Preparation Support for Lelystad Airport Consultation

Report for LVNL

Document title	Preparation Support for Lelystad Airport Consultation Report for LVNL
Author	Helios
Produced by	Helios 29 Hercules Way Aerospace Boulevard - AeroPark Farnborough Hampshire GU14 6UU
Produced for	LVNL
Helios contact	Alan Corner Tel: +44 1252 451 651 Fax: +44 1252 451 652 Email: Alan.Corner@askhelios.com
Version	V1.0
Date of release	06 September 2017
Document reference	P2386D009

Figure 1: Route concept A connecting routes (NM TMA A available)

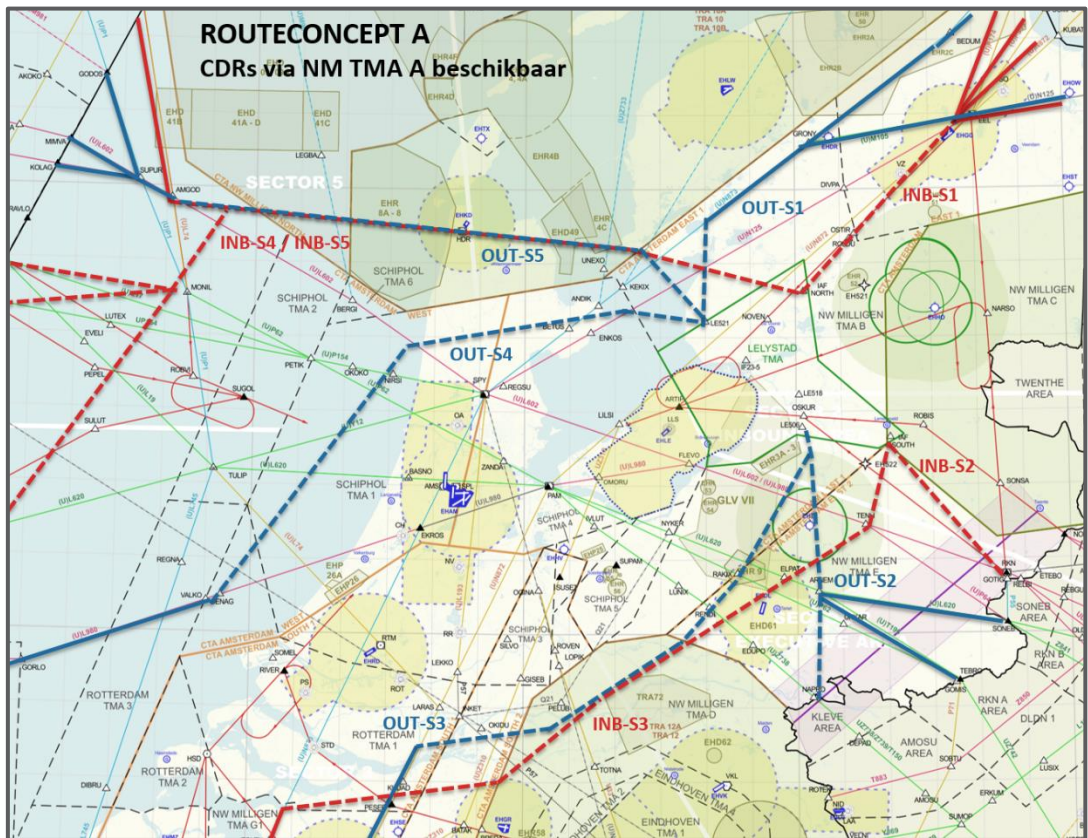
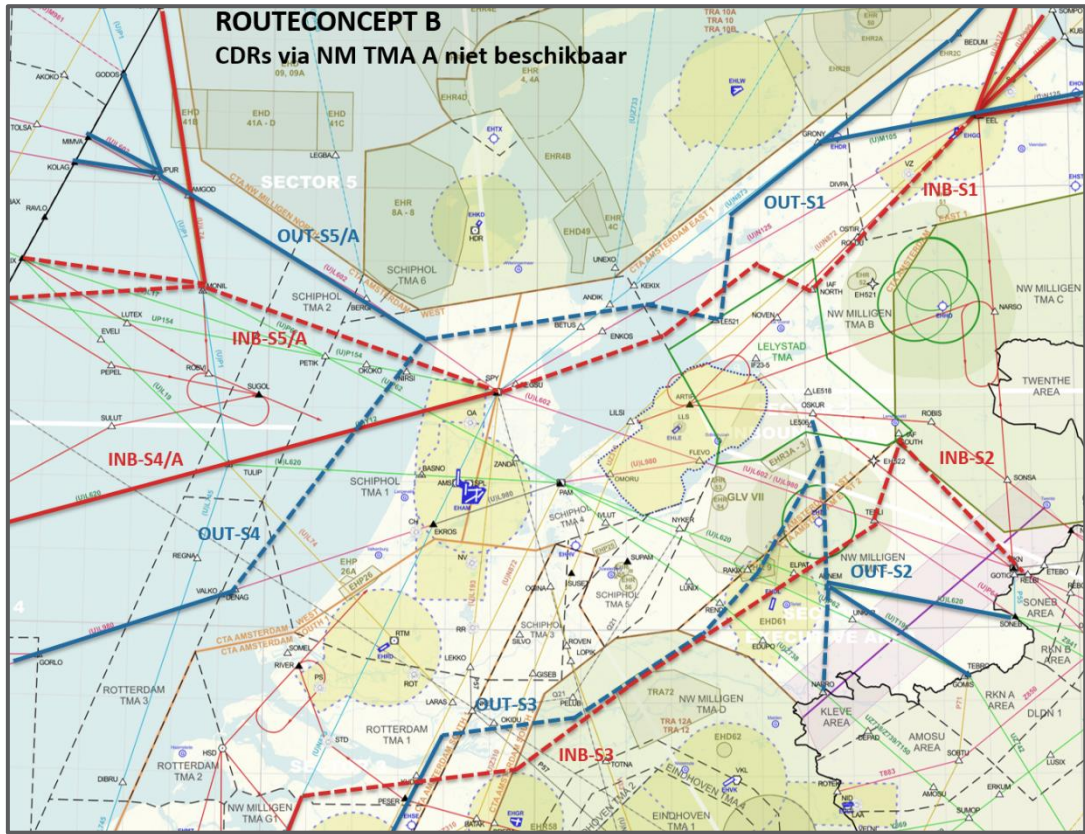
Overall and in our opinion, the proposed route-set will enable the start of operations at Lelystad in 2019.

In terms of the down-selected routes, we are content that within the constraints of the existing airspace and the 'given' design of the Lelystad airport arrival and departure routes (Conops B+), the selected routes appear to be the most suitable from those proposed by LVNL and CLSK to enable the start of operations at Lelystad in 2019 whilst having least impact on Schiphol and military air traffic operations. However, there remain consequences for other airspace users which the design of procedures has not, as yet, fully resolved.

Figure 6: Lelystad Airport TMA

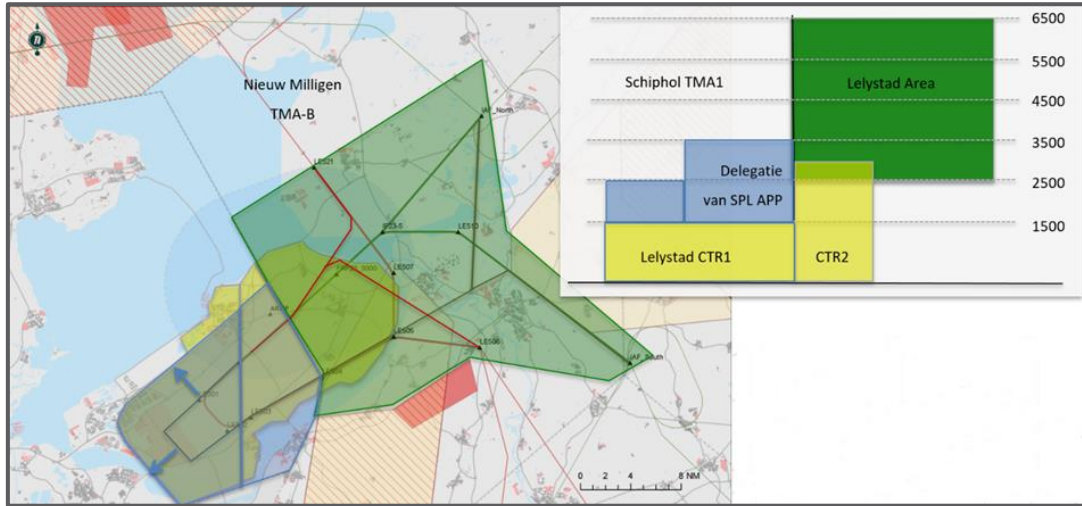
Evidently, the Lelystad airport TMA design appears to show adequate lateral containment of the Conops B+ arrival and departure routes.

Figure 7: Vertical profiles of the arrival (green) and departure procedures (red) for Runway 05

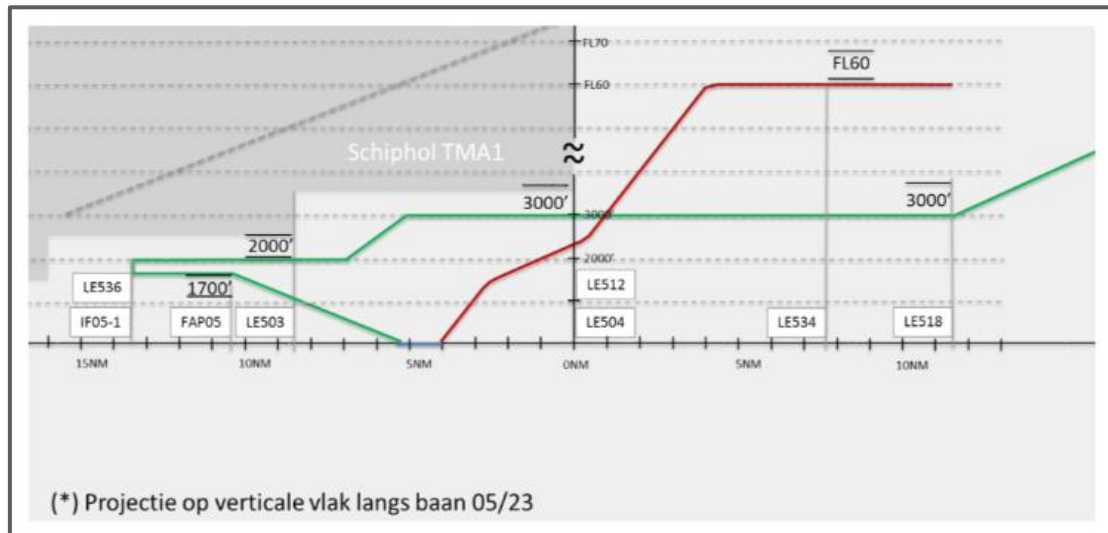
The departure procedures are shown climbing from threshold elevation to FL060 (approx. 6000ft) over a distance of approximately 11.5 NM (to waypoint LE534); this equates to a PDG of circa 8.5%. Whereas, the arrival procedure involves a series of shallow stepped descents culminating in a final uninterrupted descent from an altitude of 1700ft to threshold over a distance of approximately 6 miles; this equates to a descent gradient of circa 5.2% (3 degrees). All conceptual design gradients therefore fall within PANS OPS criteria.

Figure 8: Vertical profiles of the arrival (green) and departure procedures (red) for Runway 23

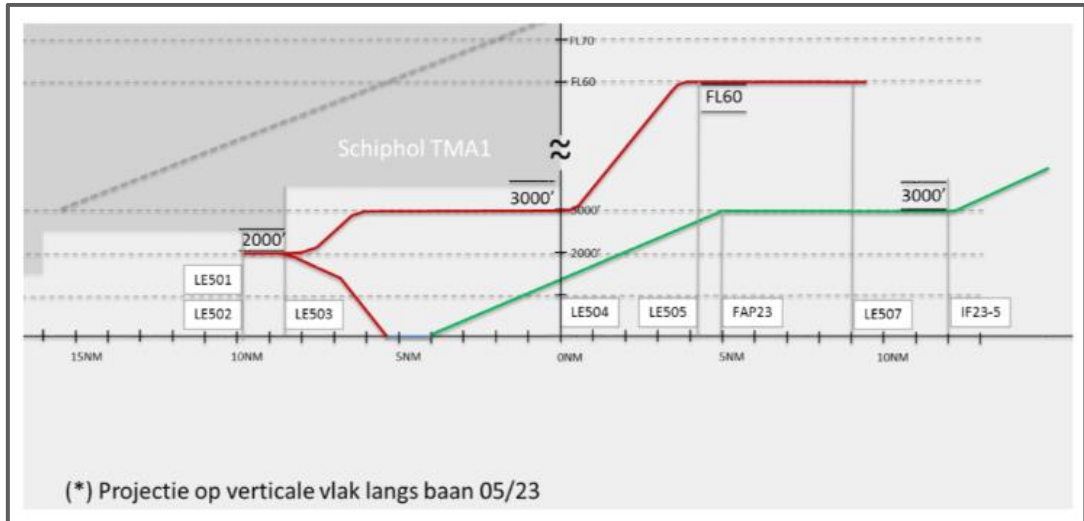
The departure procedures are shown with a series of interrupted climbing segments in order to keep departing aircraft within the stepped vertical limits of the TMA. The steepest portion involves a climb from altitude 3000ft to 6000ft over a distance of approximately 5 NM; this equates to a PDG of circa 9.9%. Whereas, the arrival procedure involves a series of shallow stepped descents culminating in a final uninterrupted descent from an altitude of 3000ft to threshold over a distance of approximately 8 NM; this equates to a descent gradient of circa 5.2% (3 degrees). All conceptual design gradients fall within PANS OPS criteria.

Figure 9: Vertical cross section of Lelystad TMA

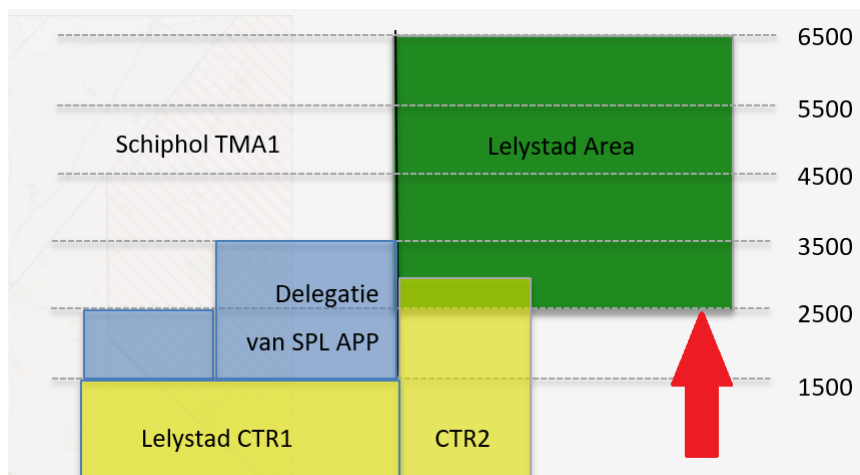
We note that whilst the Lelystad TMA achieves vertical containment of the Conops B+ routes, the base level of the Lelystad airport TMA in the vicinity of the Initial Approach Fixes at 2,500ft (as shown below in Figure 9) seems unnecessarily low, when the stated requirement is for inbounds to maintain a minimum of FL060 and to descend to 3,000ft 'as late as possible'.
